Suggestion No. 2699

Suggester proposed that the hinges on the gate at "M" Building be moved to the left side so that it will open from the right side.

PRESENT CYCLONE BARRICADE - FENCE  
M - Bldg - 26th ST L TOWER  
Approved For Release 2000/08/15 : CIA-RDP80-00832A000200070016-1

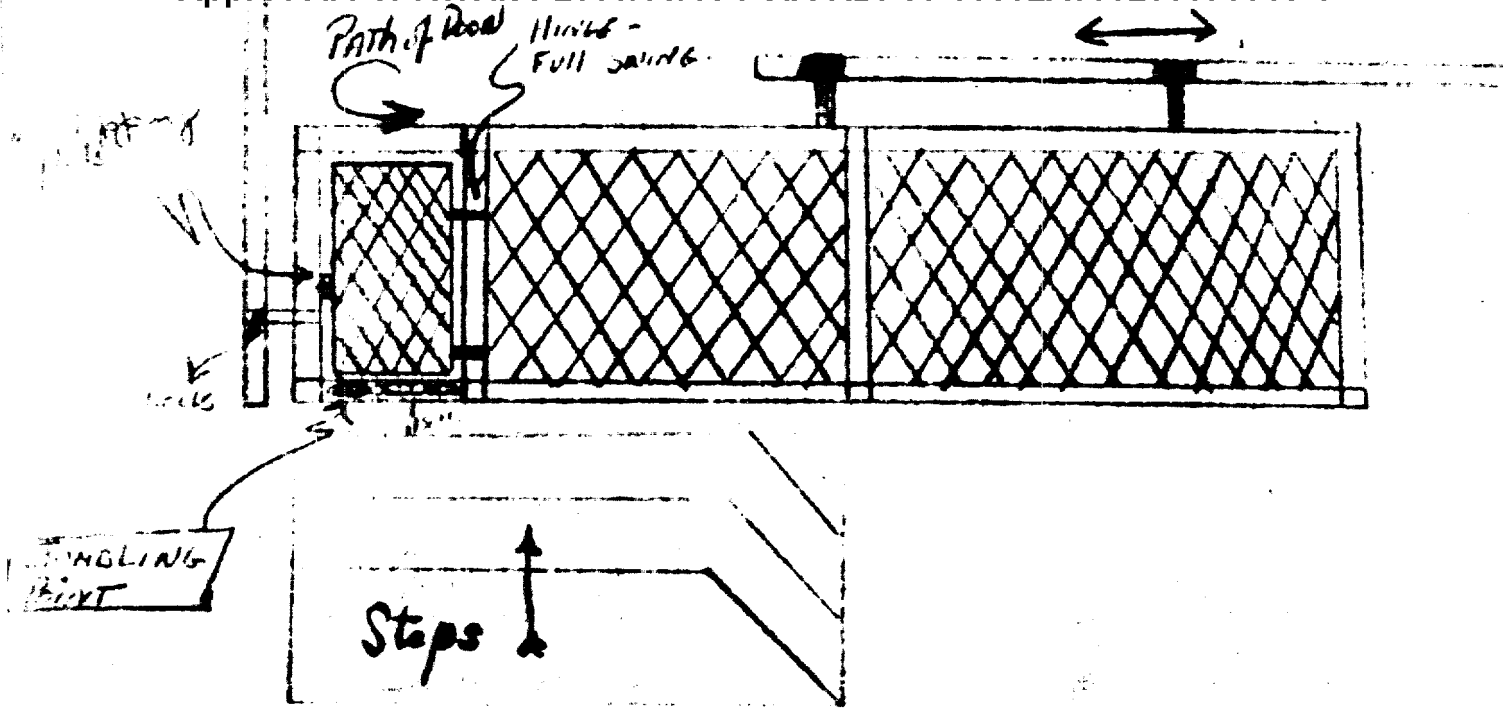
"The investigation revealed that the hinges on the gate were free swinging; therefore, it would not be necessary to relocate them. However, the eyebolt which prevents the gate from swinging out can be turned to a horizontal position thus permitting a full swing of the gate in either direction. A tripping hazard can be eliminated by removing the horizontal pipe presently exposed under the gate.

"Contact has been made with the Public Buildings Service with respect to effecting changes mentioned above. Efforts are being made to have the work accomplished as quickly as possible.

"It is recommended that the Suggester be given a nominal cash award for an idea which will result in safer conditions for Agency personnel.
